1. The specifications and drawings for Invitation No. DACW64-02-B-0032, Public Facilities, Non-Overflow Dam, Wallisville Lake, Trinity River and Tributaries, Texas, advertised 2 August 2002, and for which bids are to be opened on 4 September 2002, are hereby modified as follows:

**TRINITY RIVER AND TRIBUTARIES,  
TEXAS, WALLISVILLE LAKE, NON-  
OVERFLOW DAM, PUBLIC FACILITIES**

(To Accompany Amendment No. 0001 to Invitation No. DACW64-02-B-0032)

THIS ATTACHMENT ACCOMPANIES AMENDMENT NO. 0001  
 TO INVITATION NO. DACW64-02-B-0032.  
 ( ATTACH TO DRAWING C-3 )

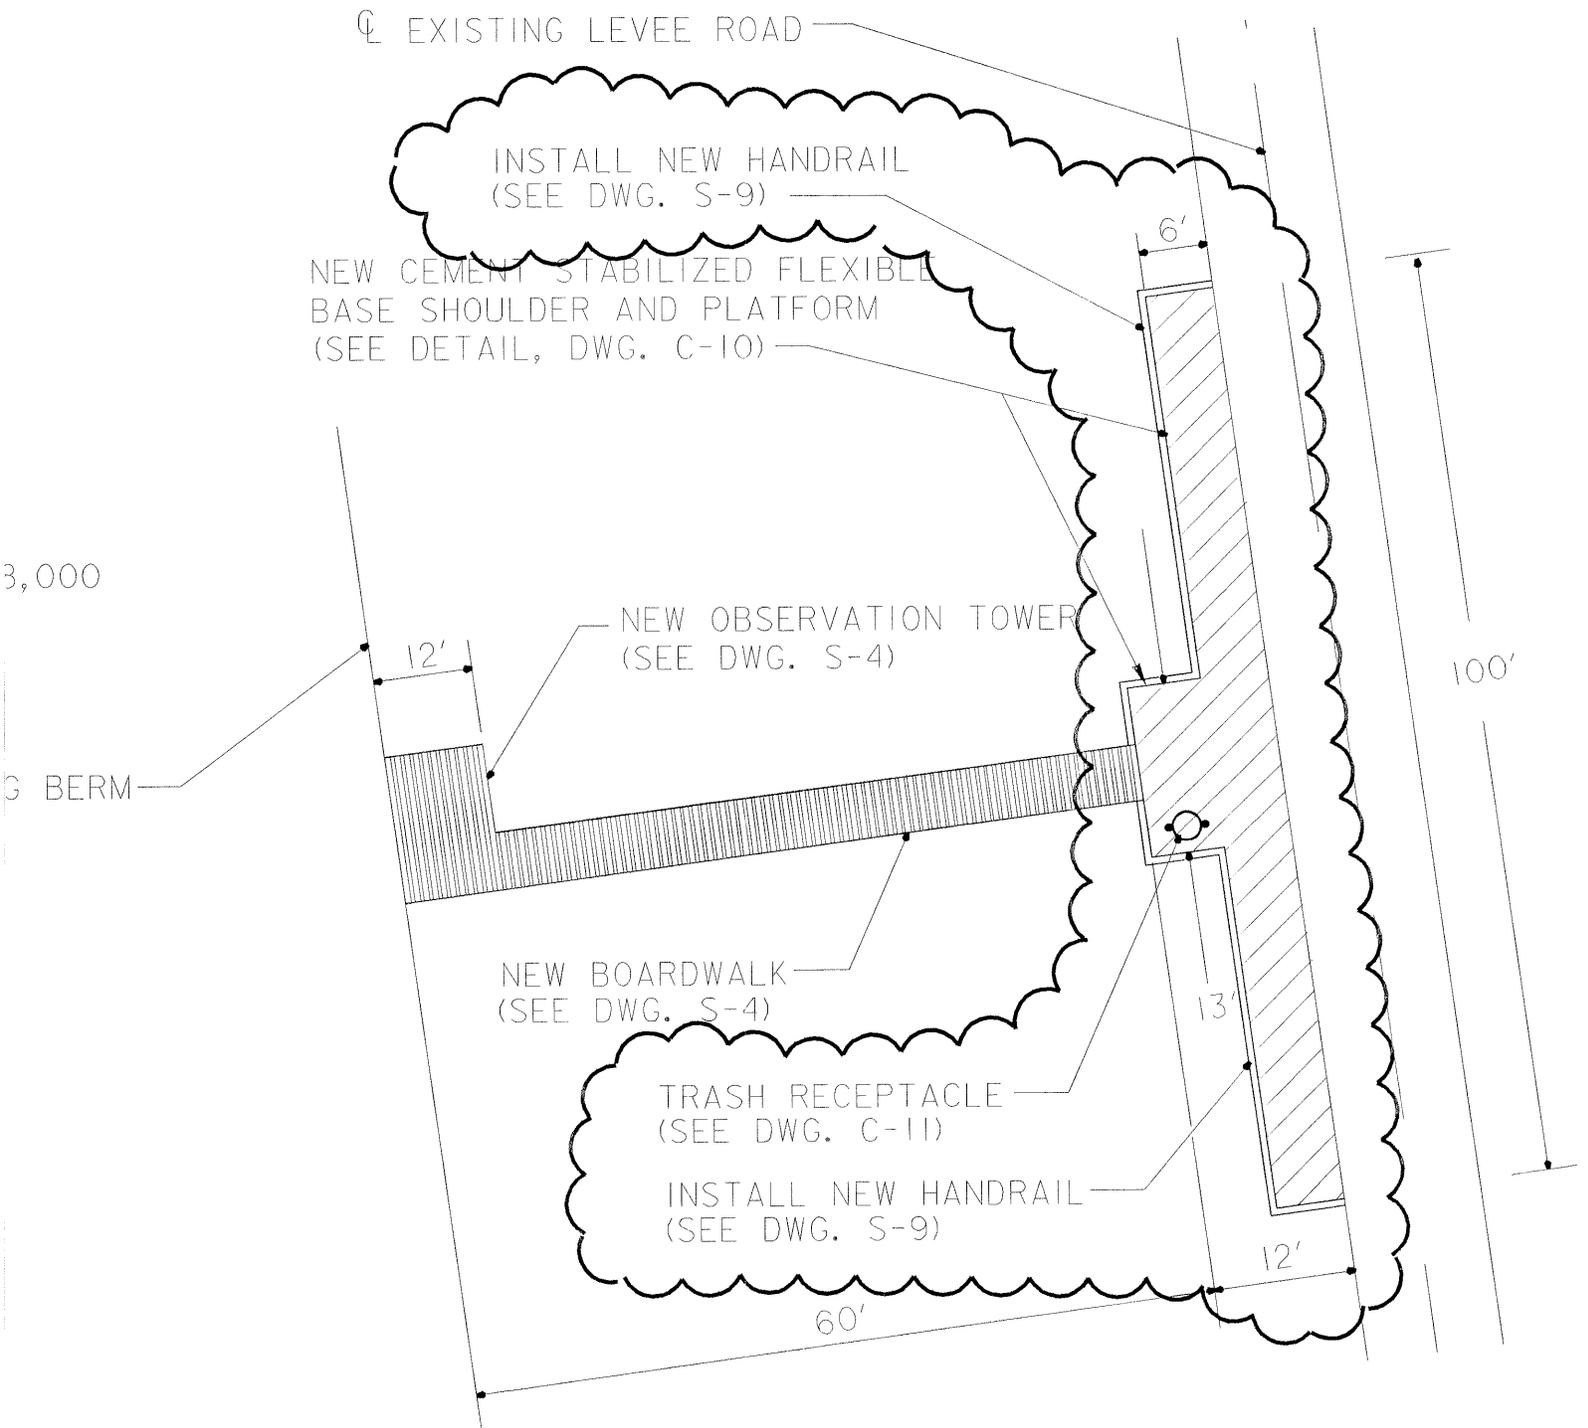
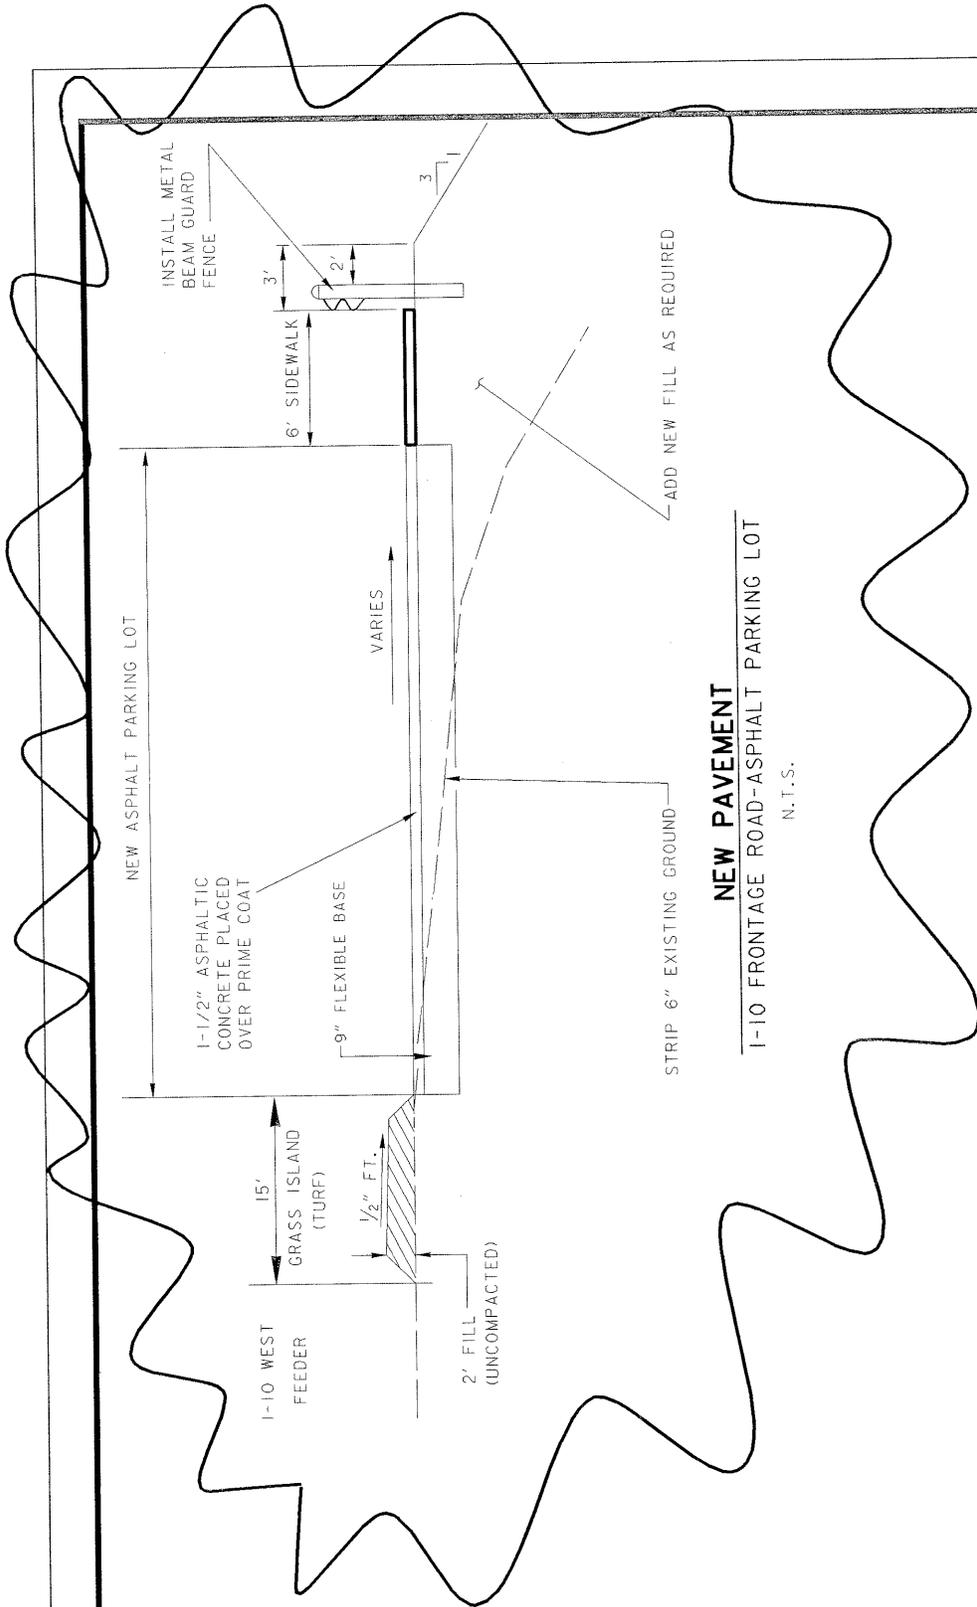
(2) Drawing No. C-3. - The enclosed "ATTACHMENT NO. 1" shall be attached to and become a part of this Drawing. In the Notes, delete "NOTE 4".and add "NOTE 8 EXPANSION JOINT MATERIAL SHALL BE PLACED AT END OF THE NEW 6' SIDEWALK WHERE IT ABUTS THE RESTROOM FLAB AND WHERE IT ABUTS THE PAVILION SLAB."

THIS ATTACHMENT ACCOMPANIES AMENDMENT NO. 0001  
 TO INVITATION NO. DACW64-02-B-00032  
 ( ATTACH TO DRAWING C-10 )

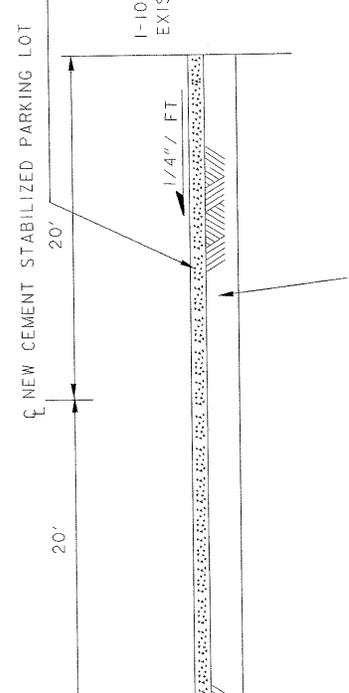
(8) Drawing No. C-10. - The enclosed "ATTACHMENT NO. 4" shall be attached to and become a part of this Drawing. In the SIDEWALK DETAILS - EXPANSION JOINT, change the following NOTE from "PREMOLDED EXPANSION JOINT FILLER" to "PREMOLDED EXPANSION JOINT FILLER SHALL CONFORM TO ASTM D 1752, TYPE 1." Also on the SIDEWALK DETAILS, add the following GENERAL NOTES:

"1. PROVIDE TRANSVERSE CONTRACTION JOINTS AT INTERVALS NOT EXCEEDING 5'-0" ON CENTER.

"2. PROVIDE EXPANSION JOINTS AT INTERVALS NOT EXCEEDING 40'-0" ON CENTER."

ADD 9" OF FLEXIBLE  
 BASE AND STABILIZE  
 WITH CEMENT

SEE F-4 FOR INTERSECTION DETAIL (ATTACH TO DWG. F-3B)

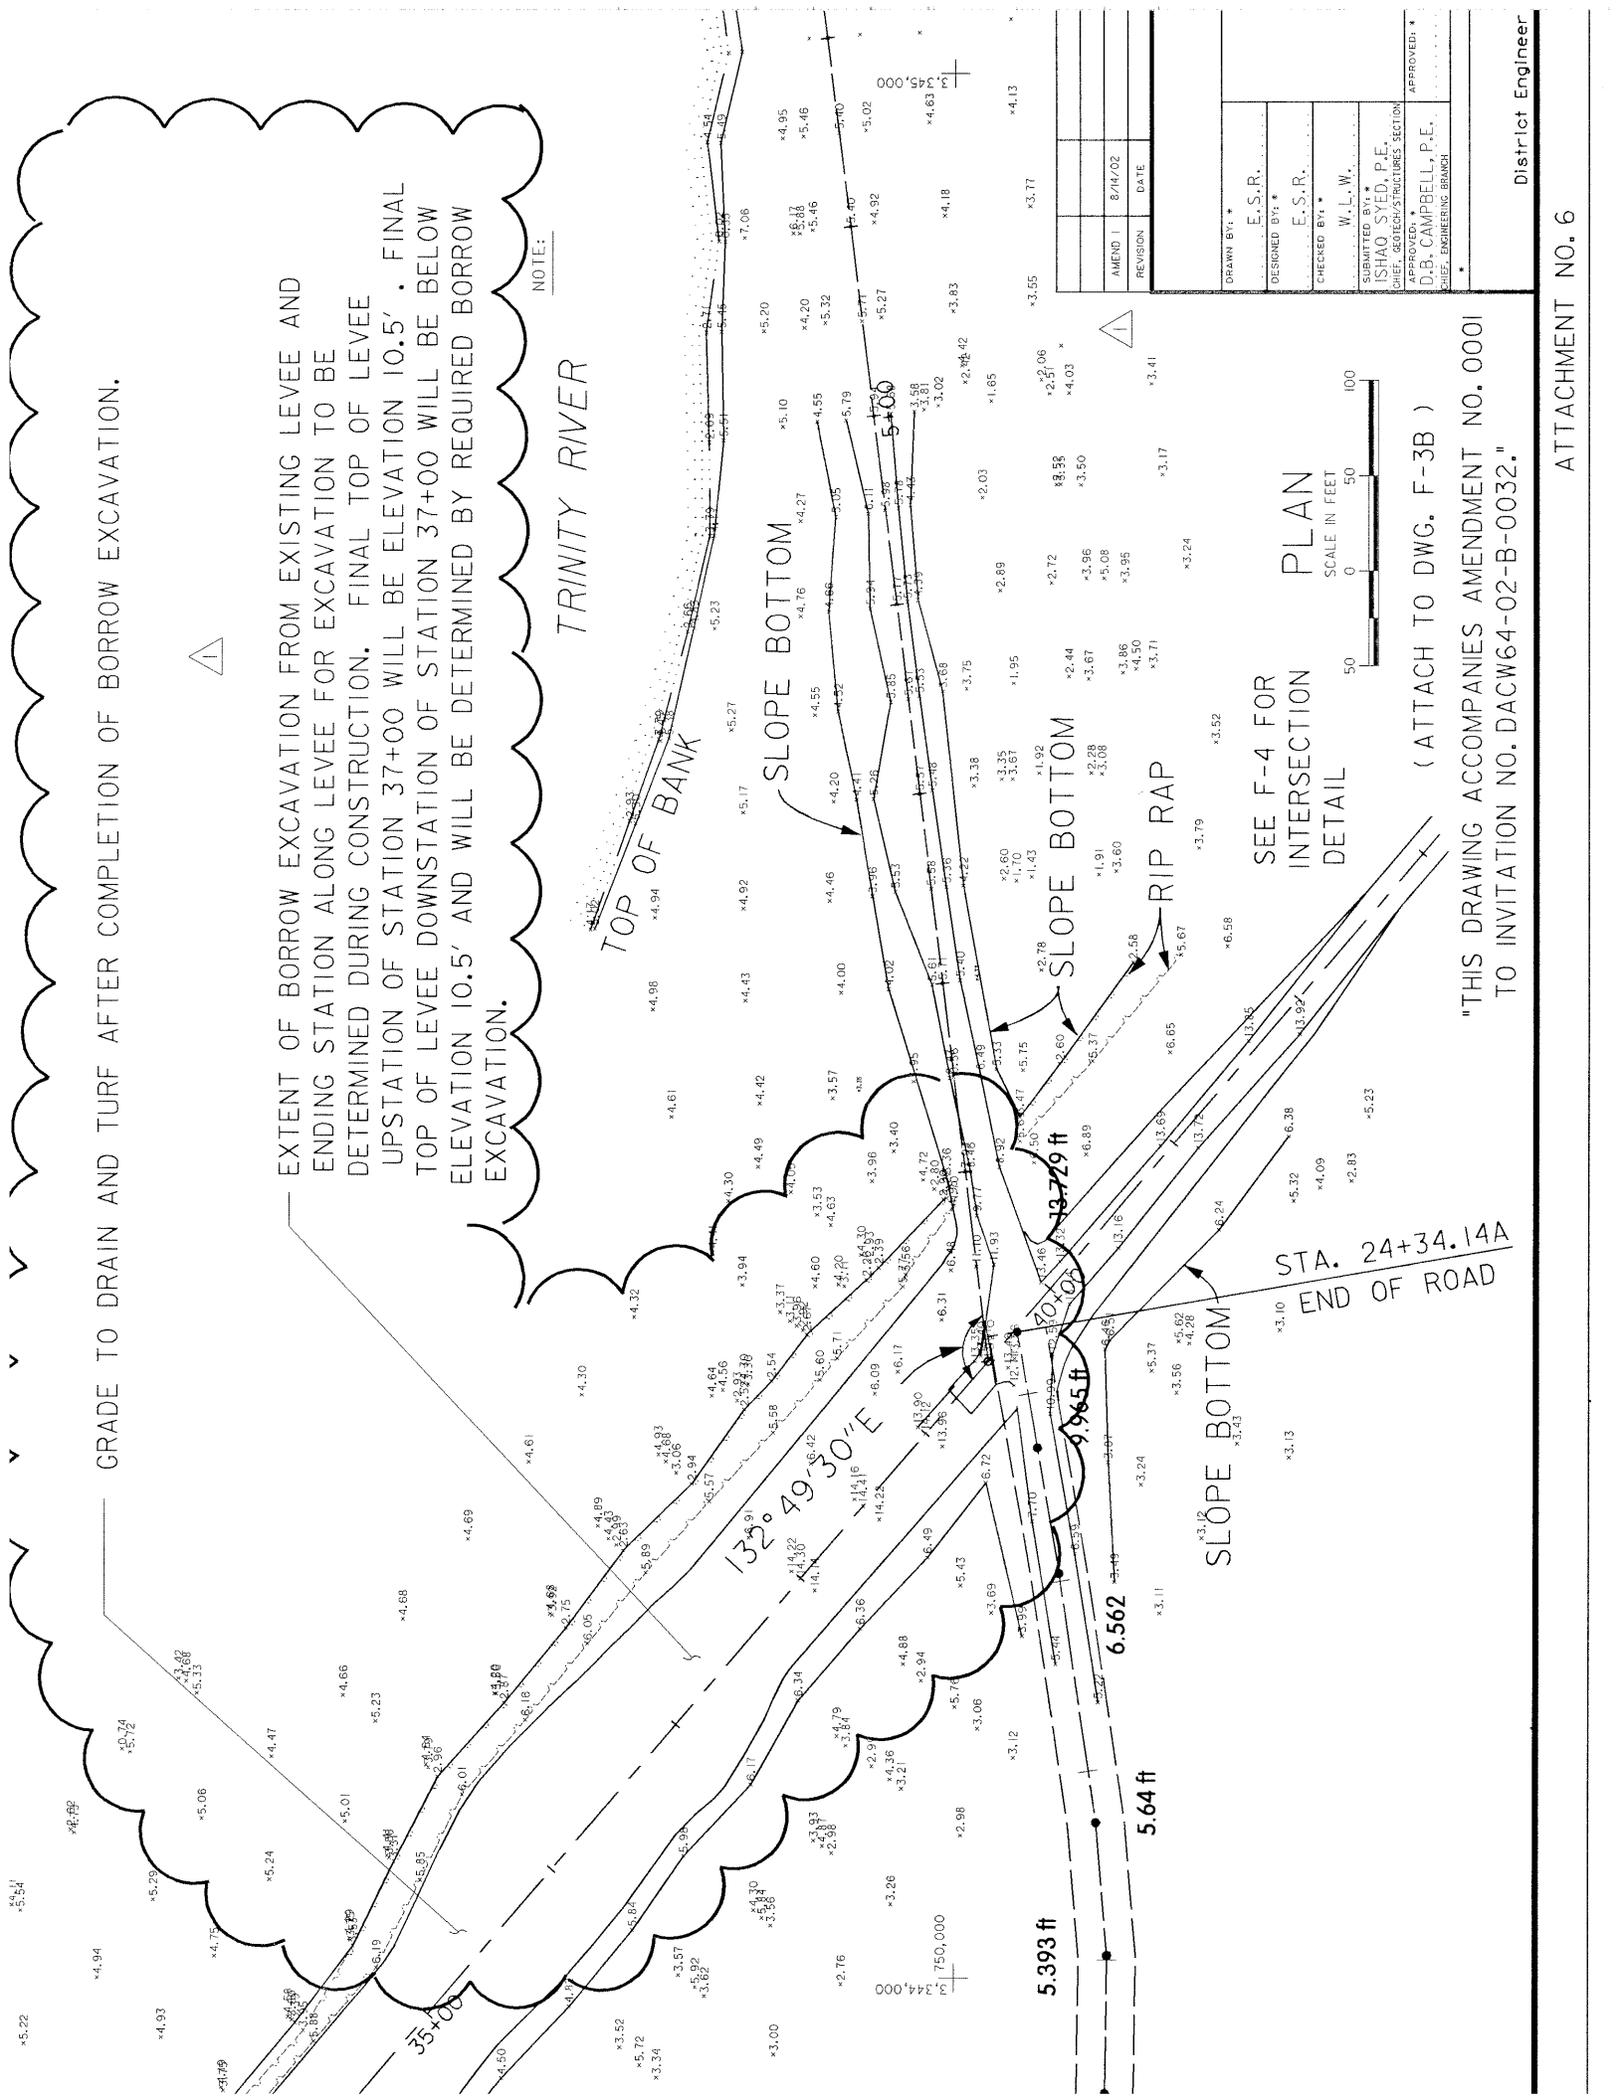
(16) Drawing No. F-3B. - The enclosed "ATTACHMENT NO. 6" shall be attached to and become a part of this Drawing. Also, on the PLAN, add the following new Note: "NOTE: THE RIPRAP SLOPE PROTECTION AT THE CULVERTS SHALL EXTEND 5 FEET BEYOND THE CENTERLINE OF THE END CULVERTS, FOR A TOTAL LENGTH OF RIPRAP OF 75 FEET ALONG EACH SLOPE OF THE ACCESS ROAD."

| Prepared under the direction of<br>Leonard D. Waterworth, Col., C.E.,<br>District Engineer                          |         | DRAWING NUMBER<br><b>C-9</b>   | SHEET 9 OF 35 FILE NO. TRIN 201-106 |

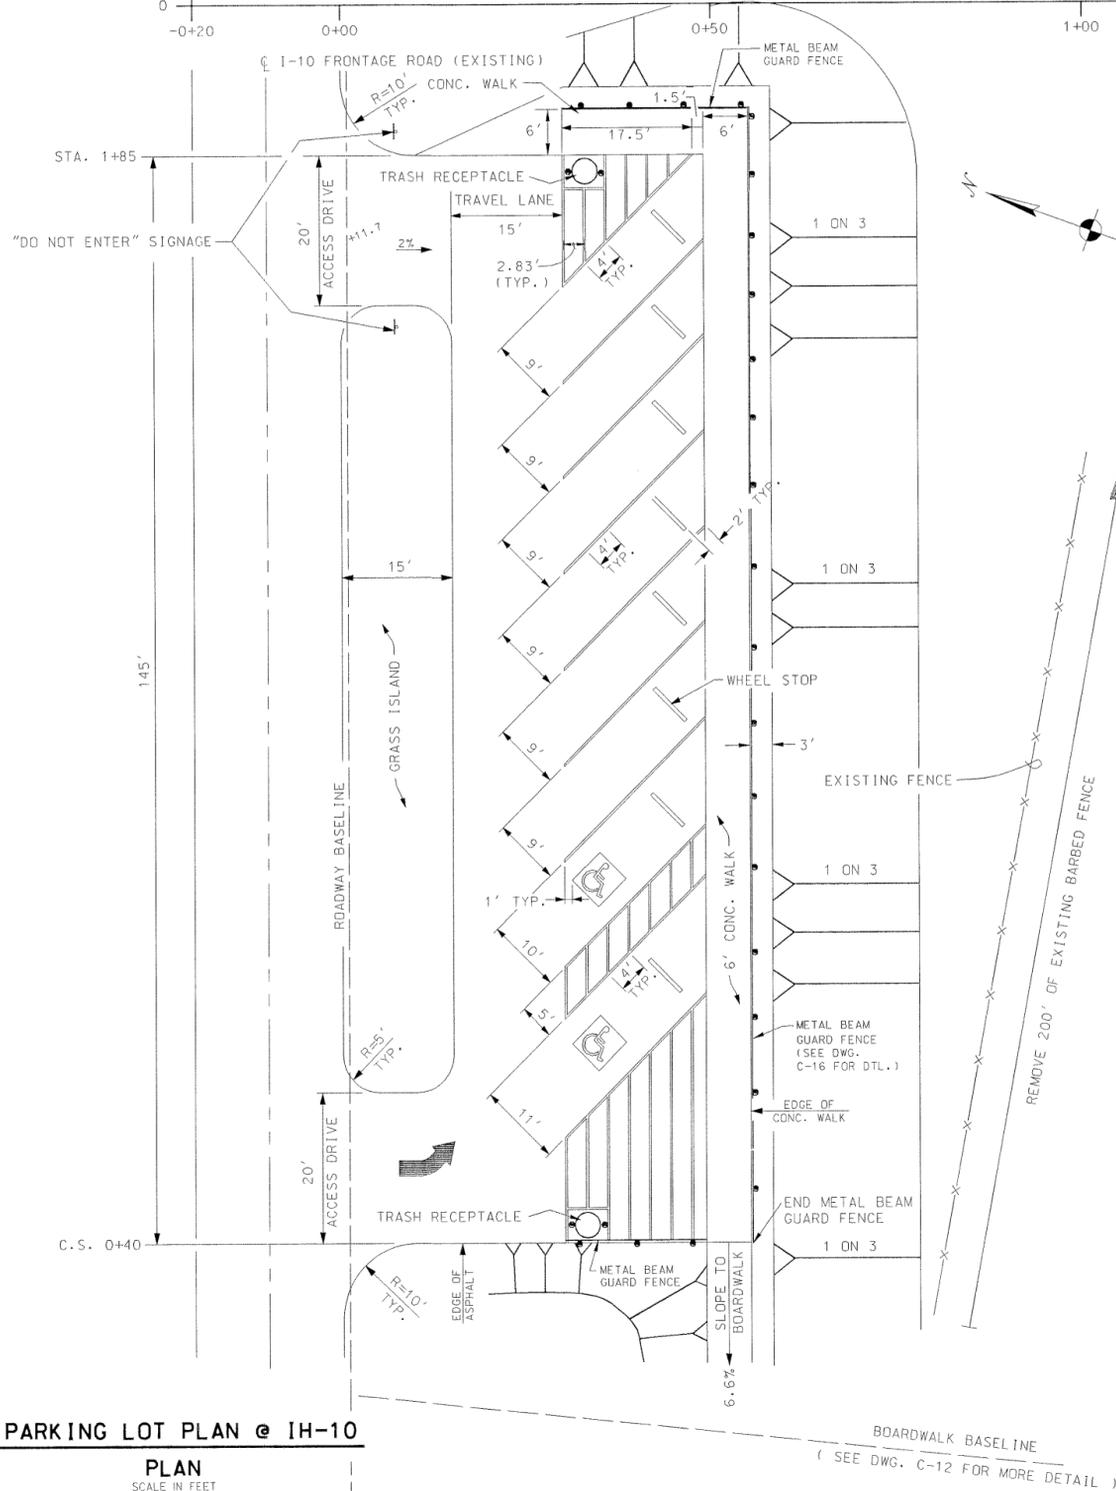
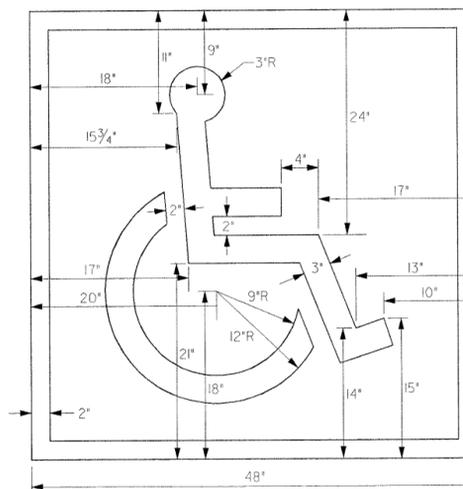
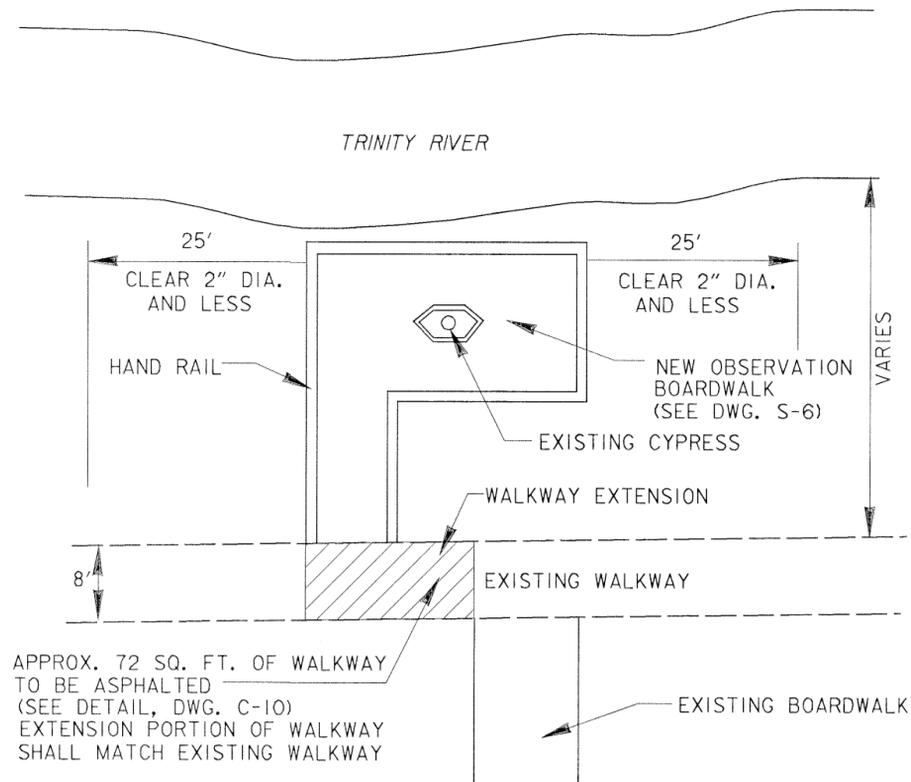
(7) Drawing No. C-9. - The enclosed "DRAWING NO. C-9" supersedes that issued with this Invitation.
